**ENGINEERING INFRASTRUCTURE ON HUNG HOM BAY RECLAMATION
TRAFFIC NOISE ASSESSMENT AND MITIGATION MEASURES AND
AIR QUALITY IMPACT ASSESSMENT ON UNDERPASS ALONG
HUNG HOM SOUTH ROAD**

SUMMARY

ADDENDUM NO. 1 TO SUMMARY

FIGURE B

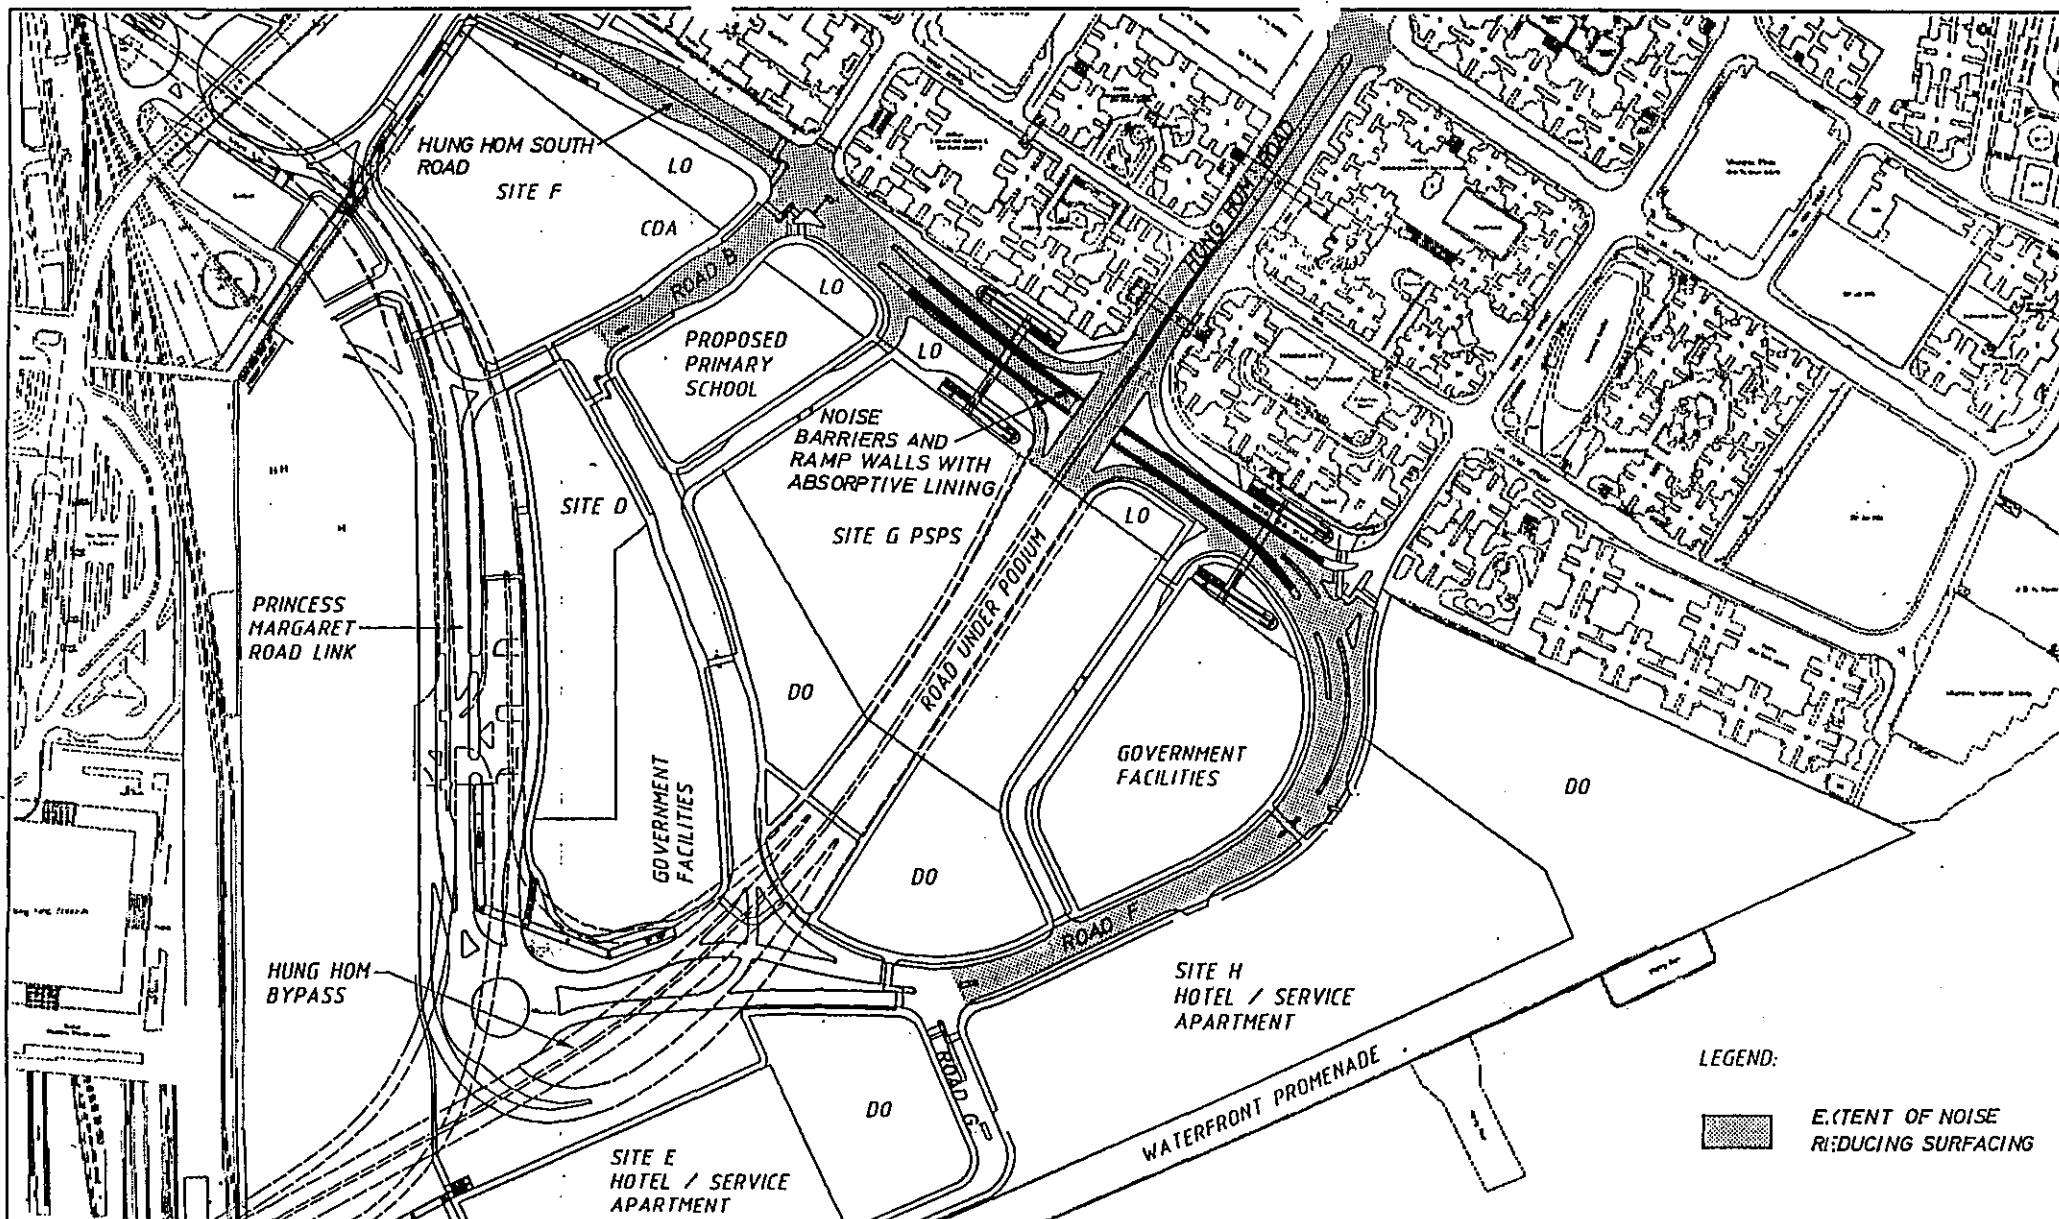
- replace "either side" with "both sides"
